MAINE TURNPIKE AUTHORITY

ADDENDUM NO. 2

CONTRACT 2026.19

RAMP IMPROVEMENTS

SHEET NUMBER: DT-02

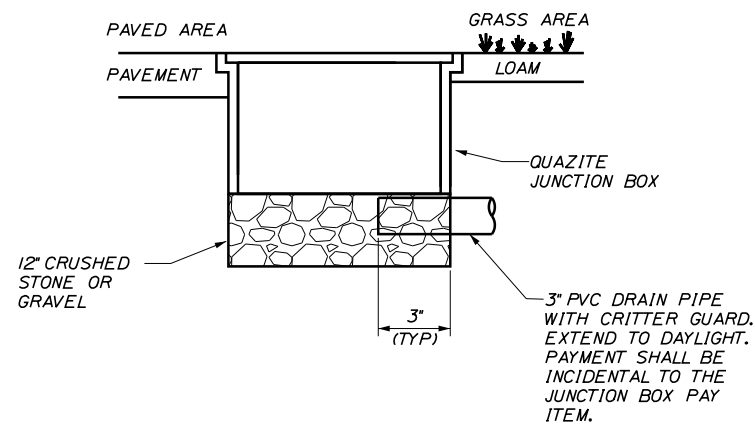
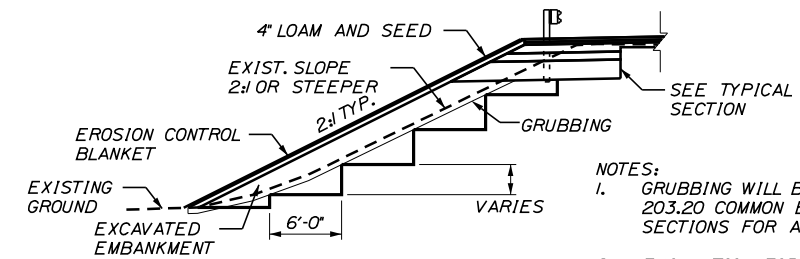
- Plan Sheet QN-01 (2 of 73): Change the quantity of item 626.22 from 760 LF to 870 LF. Delete item 626.21.
- Plan Sheet GN-01 (4 of 73): Update Lighting Notes.
- Plan Sheet DT-02 (50 of 73): Added Trench Cross Section Detail and Junction Box Cover & Frame Detail.
- Plan Sheet GP-01 (53 of 73): Revised existing conduit crossing location and proposed conduit layout, associated notes, and construction note for item 626.122.

TRENCH CROSS SECTION
NOT TO SCALE

JUNCTION BOX COVER & FRAME

1. INSTALL JUNCTION BOXES ON GRADE.
2. SPLICES IN BOX SHALL BE MADE WITH ILSCO USPA-350SS-DB DUAL RATED INSULATED, IN-LINE, WATERPROOF SPLICE, UL LISTED FOR DIRECT BURIAL (WIRE RANGE FROM 350KCMIL-10AWG STRANDED) ONLY. PROVIDE ENOUGH SLACK IN THE WIRE TO ALLOW REMOVAL OF SPLICES AND NEATLY ARRANGE WIRE IN BOX.
3. THE COVER SHALL BE LABELED WITH THE FUNCTION DESIGNATION IN 1" MIN TEXT AS FOLLOWS:
- "LIGHTING" FOR LIGHTING CONDUIT
4. COVER SHALL BE HEAVY DUTY TYPE TIER 22 WITH (2) 1/2" STAINLESS STEEL PENTA-HEAD BOLTS.
